**PRELIMINARY DRAINAGE REPORT AND MDDP ADDENDUM
FOR
HOMESTEAD NORTH AT STERLING RANCH PRELIMINARY PLAN**

**July, 2021
Project No. 25188.00**

**PCD Filing No.:
SP-20-008**

EARLY GRADING - DRAINAGE MAP
HOMESTEAD NORTH
JOB NO. 25188.00
06/29/21
SHEET 1 OF 1

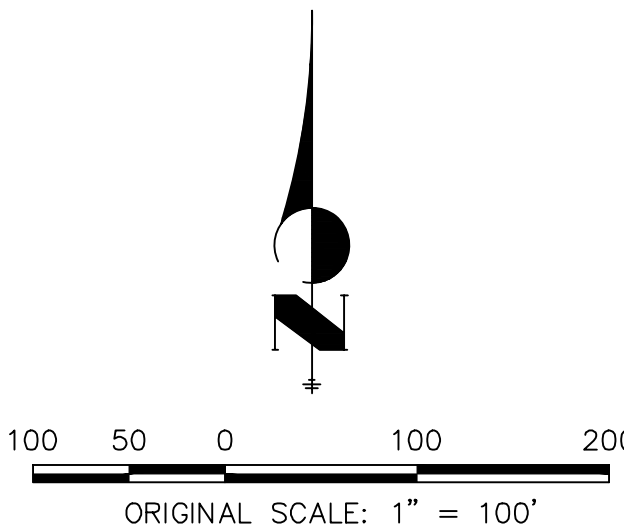
Do not show curb and gutter on grading

Provide swale cross-sections, grades

JR Response: Removed Graded Curb and gutter section from the corridor surface.

JR Response: Added

EARLY GRADING - DRAINAGE MAP

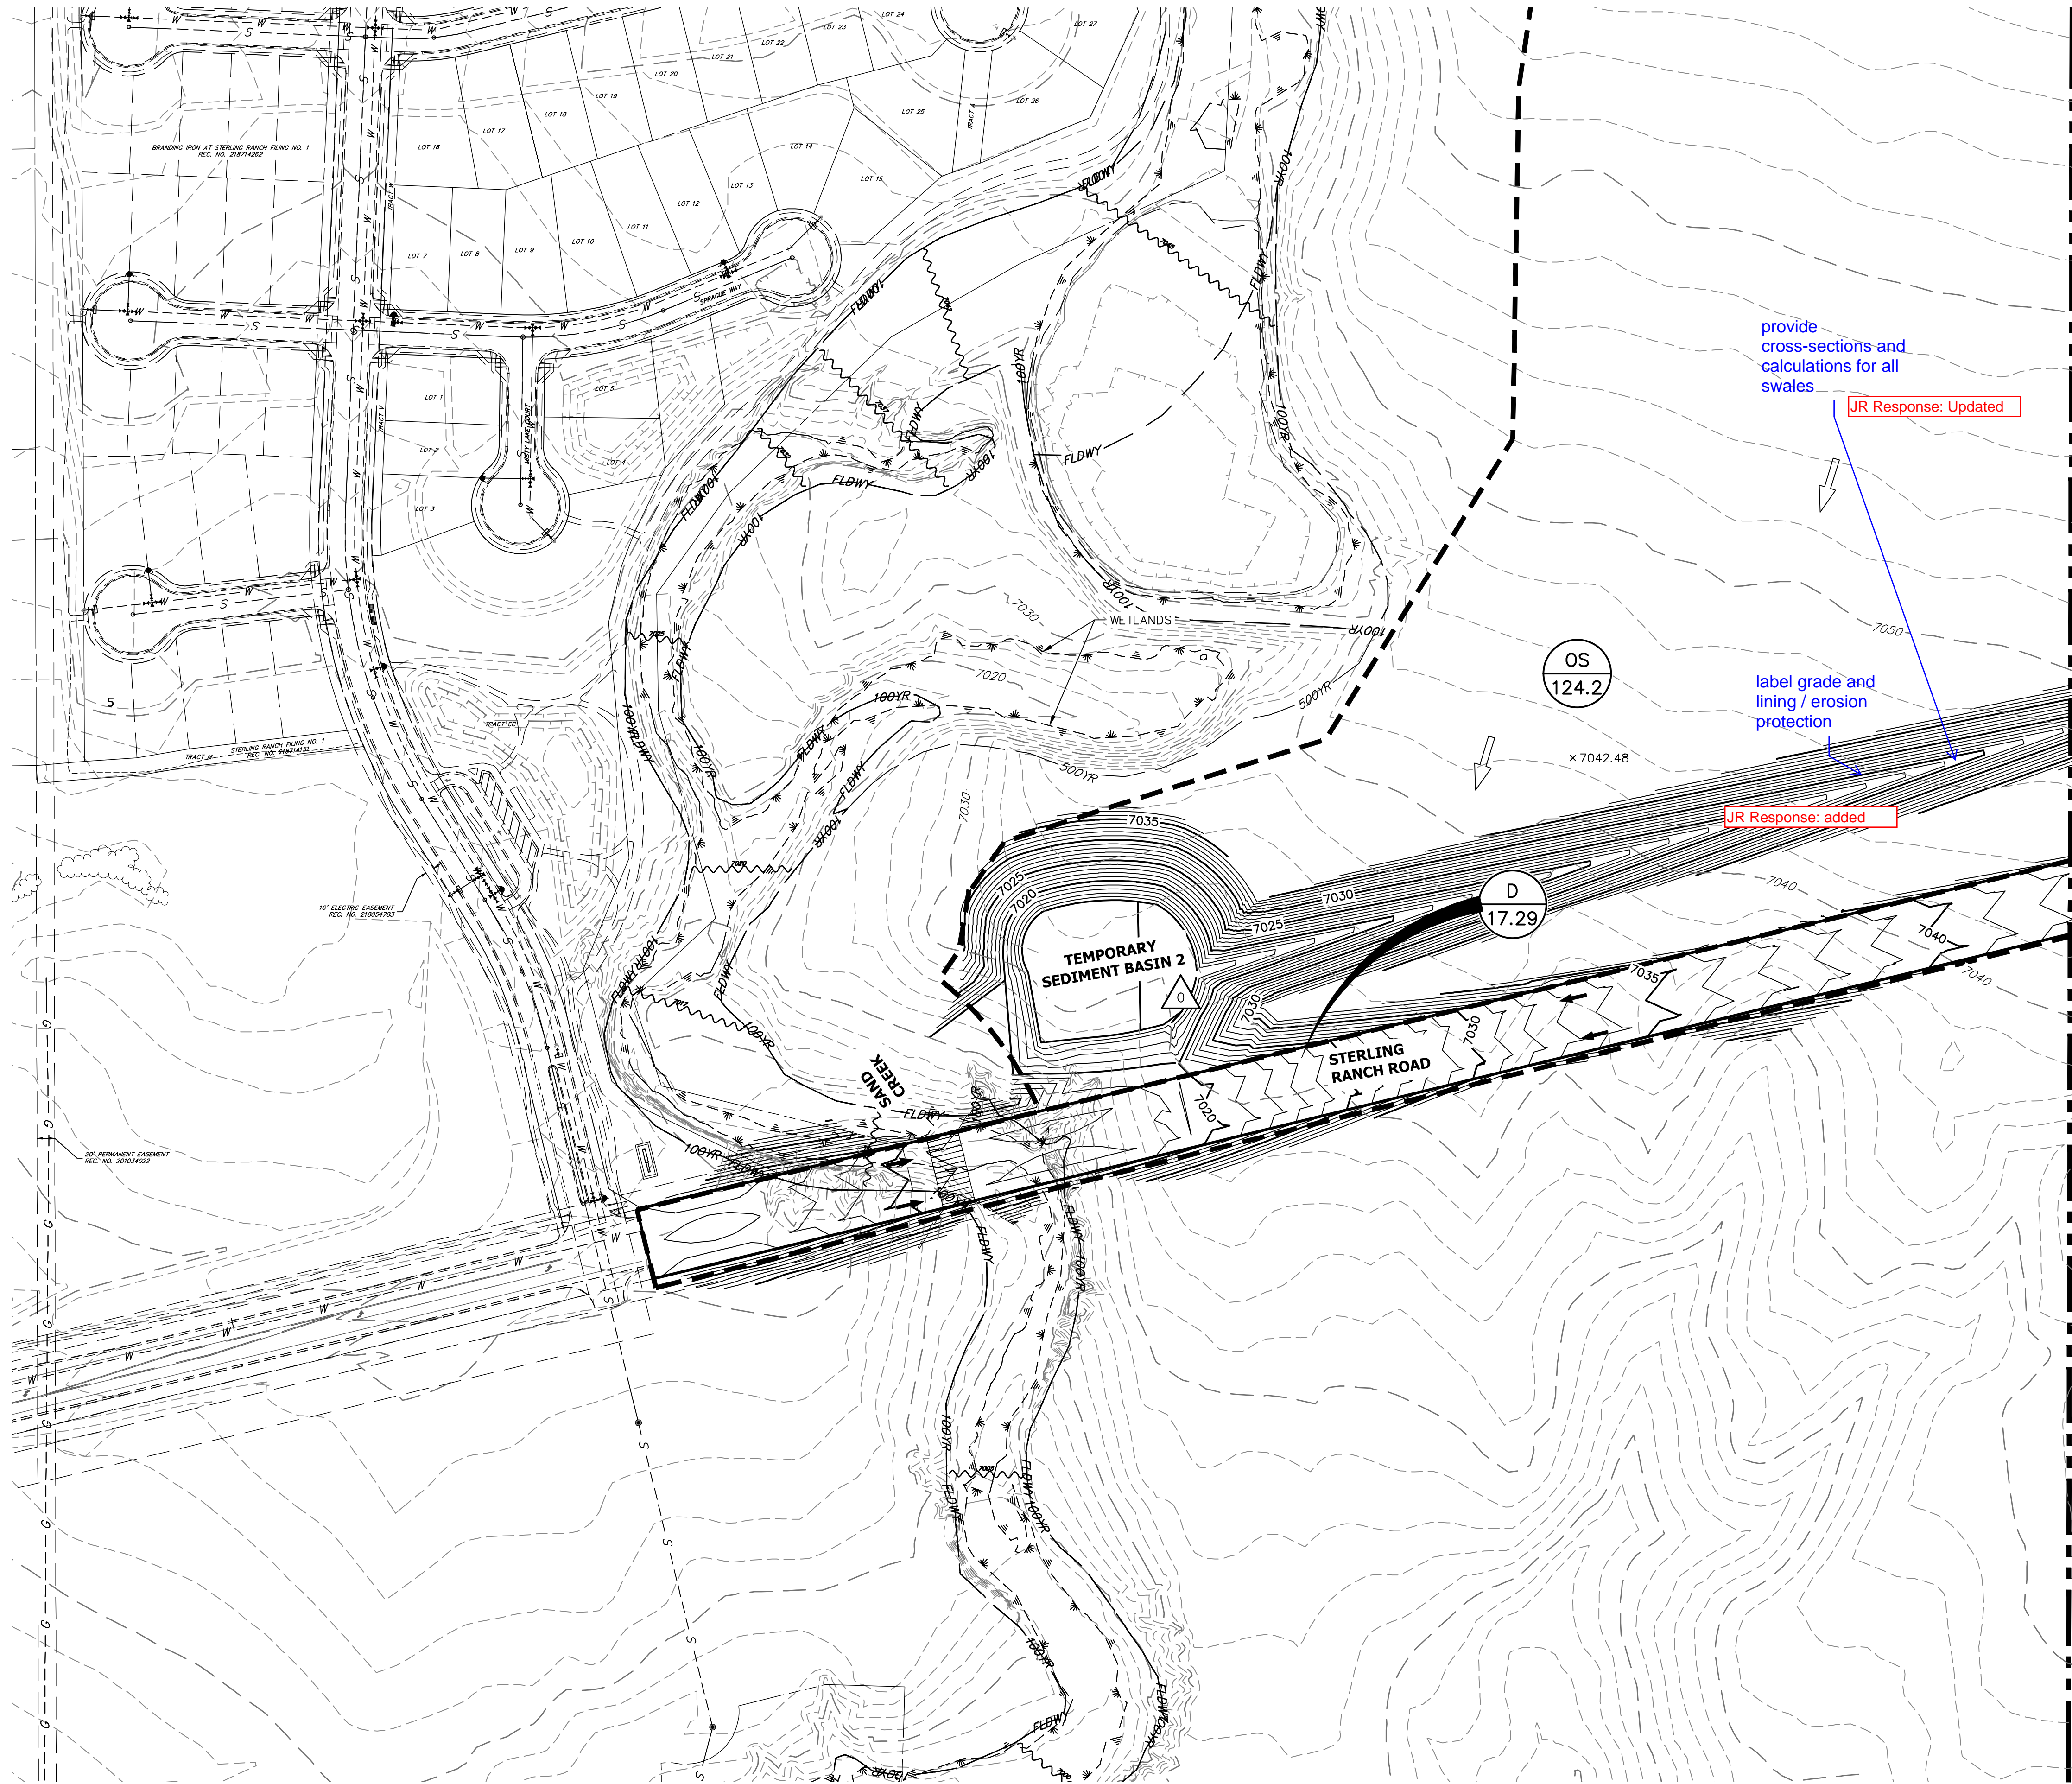
Verify size based
on contributing
area from east
side of SRR
